PLANNING COMMITTEE 11 NOVEMBER 2026

Item 5. Written representation from the public

EHDC-26-0082-FUL · WILSOM ROAD, ALTON

What the applicant's own evidence shows

Access in the floodplain, says EA

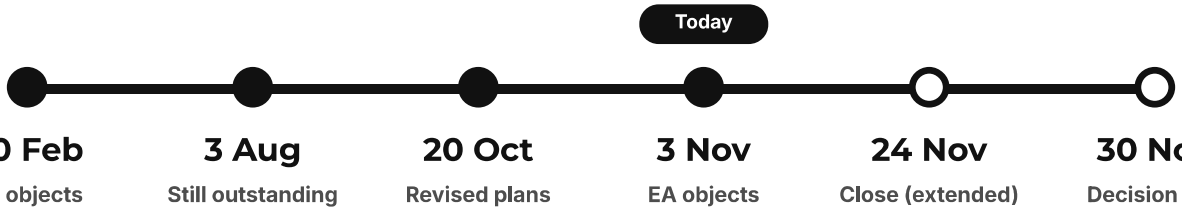
1. Access from Wilsom Road
2. Northern wetland

They say no floodwater is modelled along the access road. The EA found the access route and bridge are in the functional floodplain.

UNRESOLVED
Will the EA objection be resolved before a decision?

The flood regulator still objects to the revised plans

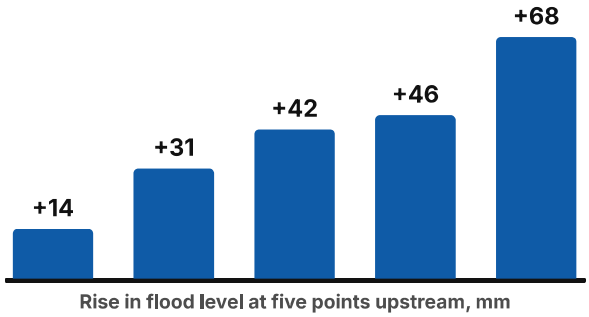
They say their flows "have been reviewed". On 3 Nov the EA objected again: it cannot review their model without an up-to-date hydrology study, and their flood storage compensation is inadequate.

Will the EA objection be resolved before a decision?

A blocked bridge raises water up to 884 mm

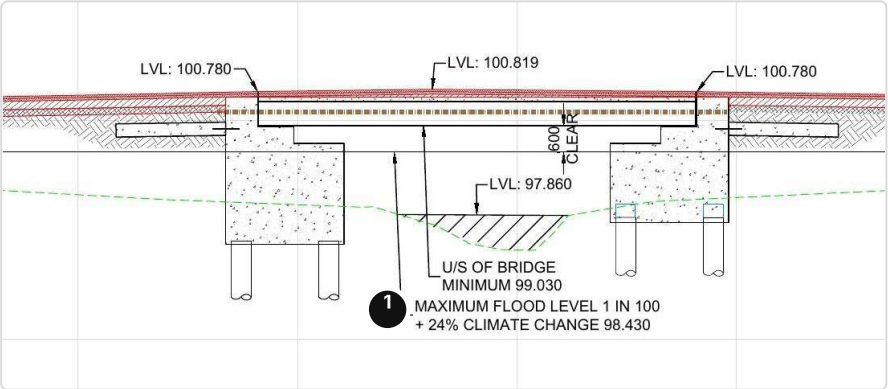
They say: "minimal change". Their own tables say otherwise.

Rise in flood level at five points upstream, mm

+884 mm

if 80% blocked, against the level without the scheme

Our calculation from their Table 2 (their text says 800 mm)

Has the effect of a blocked bridge upstream been shown acceptable?

Their latest bridge drawing is still preliminary

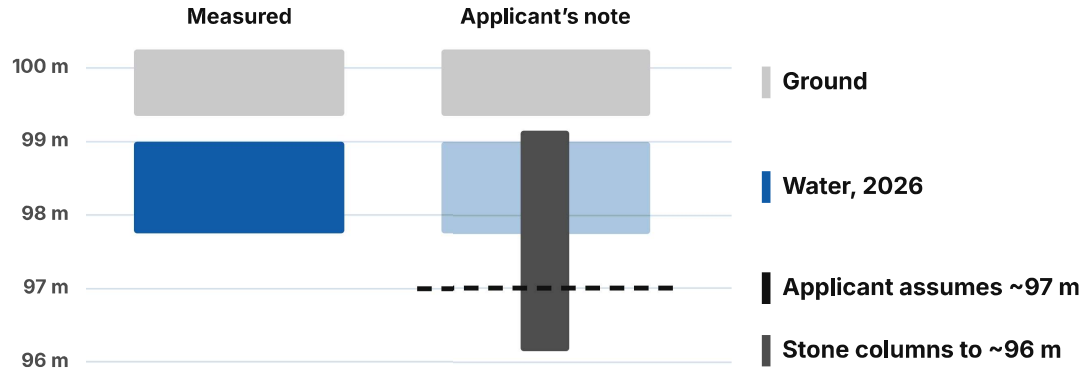
They say: "The proposed bridge crossing is unchanged".

1. **Drawn to 1 in 100 + 24%**
2. **EA asked for 36%**
3. **Marked "Preliminary"**

Blocked 80%, their model puts water just upstream at 99.46 m, above the 99.03 m underside (our calc.). RSK accepts it "exceeds the soffit level".

Has a full bridge design been tested at 36% and when blocked?

Their picture leaves out the HGVs

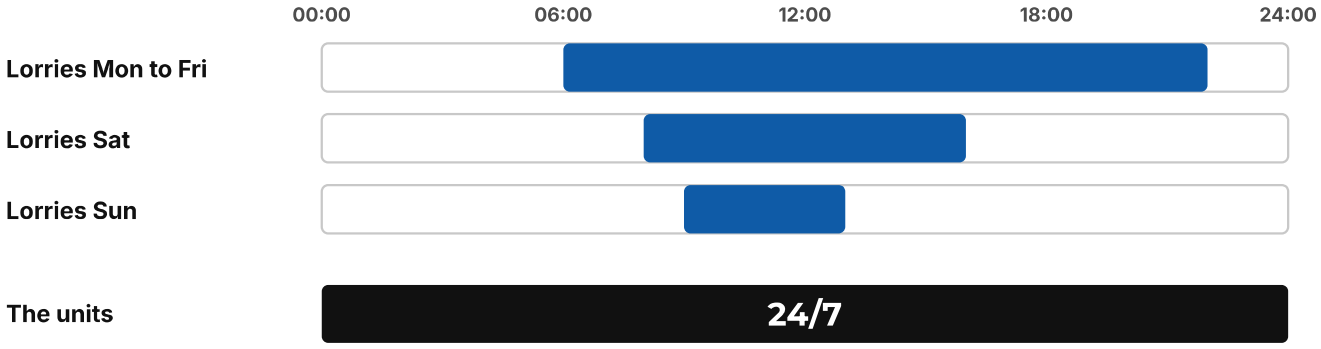
1. **No lorries visible**
2. **No forklifts visible**
3. **Planting shown already mature**

Has the visual impact been judged with 54 HGV movements a day?
